FROM: Northern States Power Co. Minneapolis, Minnesota 55401 A. V. Dienhart		DATE OF DOC NONE	DATE REC'D 3-20-74	LTR	MEMO	RPT	OTHER
TO:		ORIG	CC	OTHER	SENT AEC PDR <u>X</u>		
		NO ORIG			SENT LOCAL PDR <u>X</u>		
CLASS	UNCLASS XXXXX	PROP	INPUT	NO CYS REC'D 0	DOCKET NO: 50-263		
DESCRIPTION: No Ltr of trans rec'd.....				ENCLOSURES: Response to AEC Questions on Monticello High Energy Line Breaks Outside of Containment			
ACKNOWLEDGED				DO NOT REMOVE			
PLANT NAME: Monticello				(40 cys rec'd)

RESPONSES TO AEC

QUESTIONS ON MONTICELLO HIGH ENERGY
LINE BREAKS OUTSIDE OF CONTAINMENT

SECTION-DD

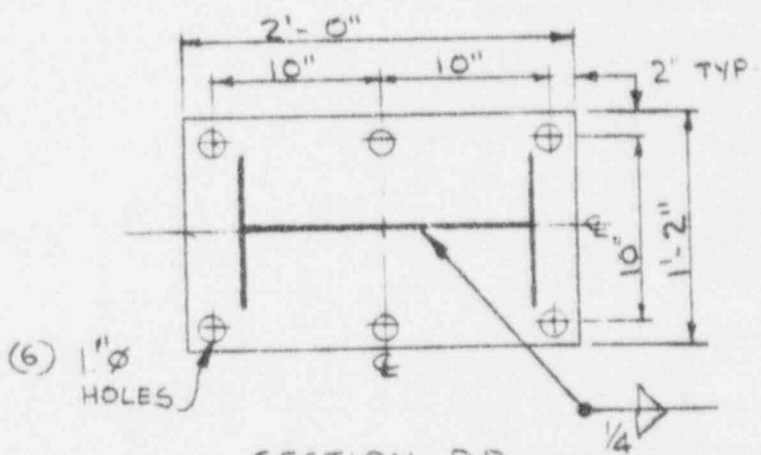
3. QUESTION: Submit details of the additional protection mentioned in paragraph 6.2.2(1).

ANSWER: The additional protection envisioned at the time of the report was a plate protecting the turbine building mezzanine floor (elevation 931'0") from a jet of water impinging on the floor. This would also have provided pipe whip protection. Further analysis of the break and break locations resulted in the following:

b. Pipe Whip

In order to provide protection to the mezzanine floor against pipe whip, four restraints will be added. Detail drawings of the pipe restraints are attached. The design load for the pipe restraint was 161 kips.

With the addition of the four pipe restraints, the mezzanine floor will be protected; thereby insuring safe shutdown of the plant following a feedwater line break.
